Notice of Energy Code Objections

Applicant:	Date: 3/2/17
WIEPKE DAVID JANSEN	Job Application #: 121328205 DOC# 10
AAI ARCHITECTS, P.C.	Application Type: ASHRAE 90.1/ 2007 - NB
14 WALL STREET NEW YORK NY 10005	Premises Address: 217 West 57 th Street
NZIGOMANIS@ADAMSON-ASSOCIATES.COM	Zoning District:
416-967-1500	Block: x Lot: x
NYC Department of Buildings Examiner: Bruce R. Kahle, AIA bkahle@buildings.nyc.gov

REVIEW OF 2/16/18 Set with 3/29/17 Approved set for ENERGY CODE AUDIT: OPEN ISSUES 06/22/2015

ZONE W-37
 3" x 1'-0"

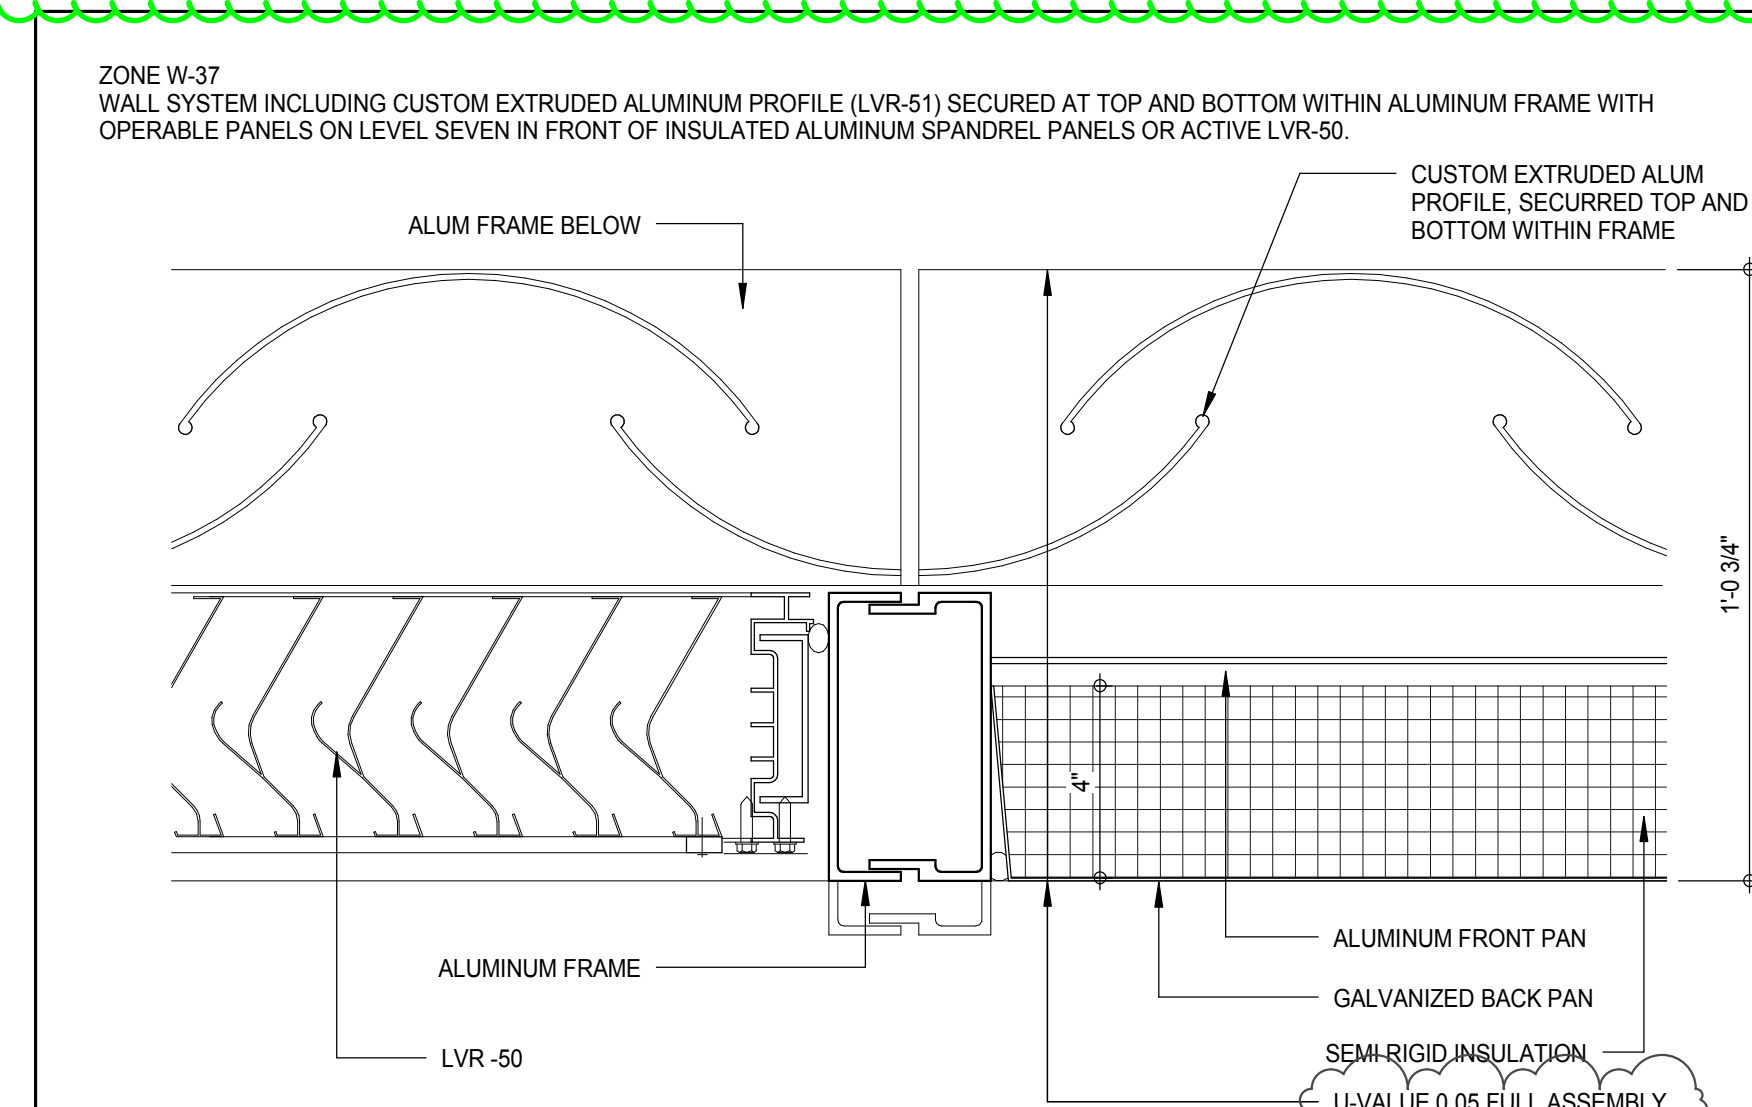
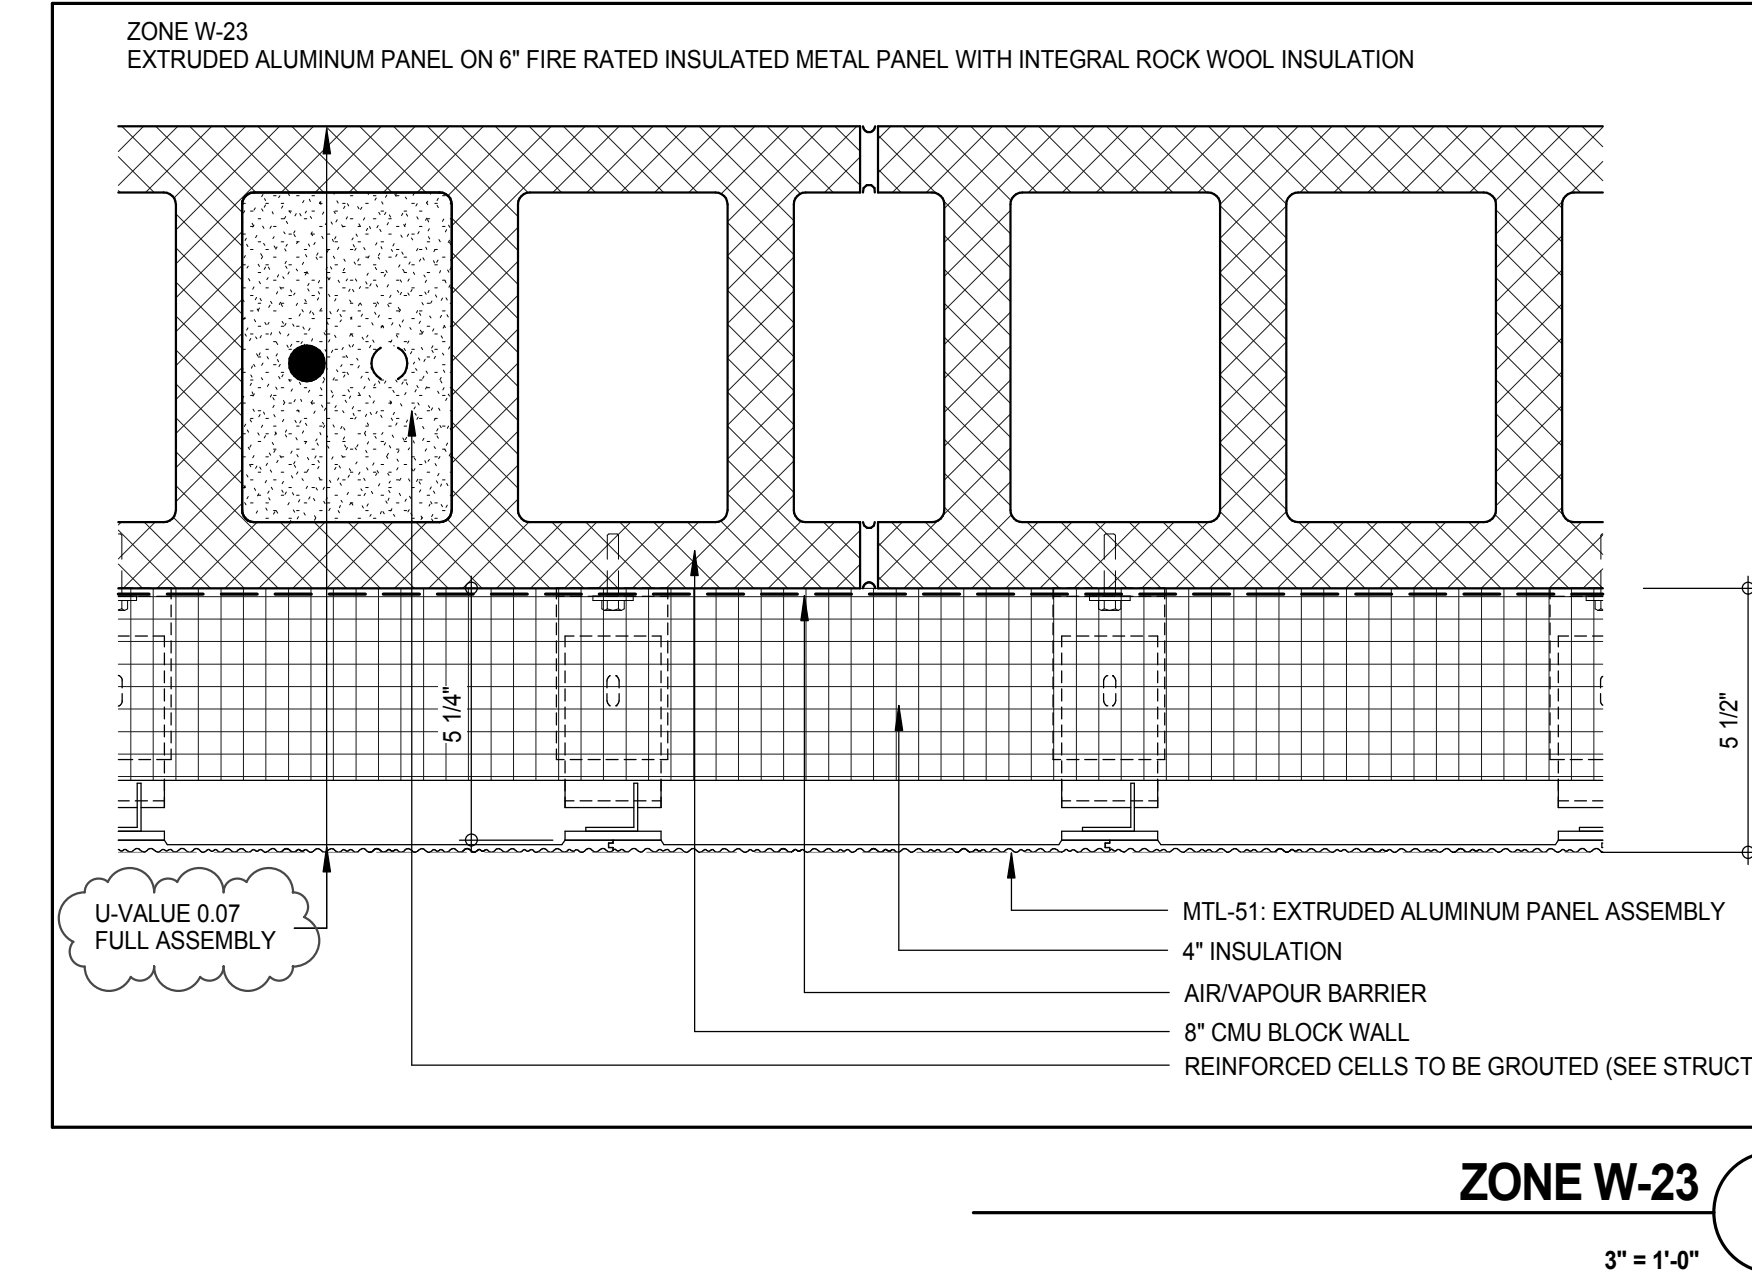
5)		1 RCNY §5000-01(g)(1); 5.4.1	Drawings do not indicate insulation R or U values for below and above grade walls and wall assemblies slabs on grade, floors and roof assemblies to match Energy Analysis.		Comment on A-802.01

6)		1 RCNY §5000-01(g)(1); 5.4.2, 5.8.2	Provide U-factor and SHGC fenestration values in drawing schedules to match or be less than those provided in the Energy Analysis.		Comment on A-802.01

7)		5.4.3	Drawings do not specify mandatory provisions for air leakage, including where applicable, building envelope, fenestration and doors, loading dock weatherseals, and vestibules.		Comment on A-802.01

C402.4 Air leakage
 Drawings do not specify mandatory provisions for air leakage, including where applicable, fenestration systems, outdoor air intake and exhaust dampers, loading dock weathertight seals, vestibules and recessed lighting seals in the thermal envelope.

DWG No: **E-602.01**

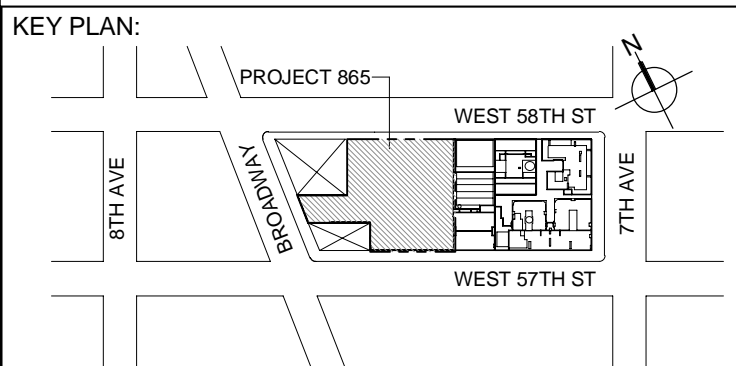
9.4.1	Provide ALL mandatory Controls and Coordinate Room labels with LPDS per Energy Model		<i>Comments on E-100.01, E-602.01 & E-605</i>
19)		9.4.1.2	Control devices to independently control general lighting within each space is missing.		<i>Comments on E-000.01</i>
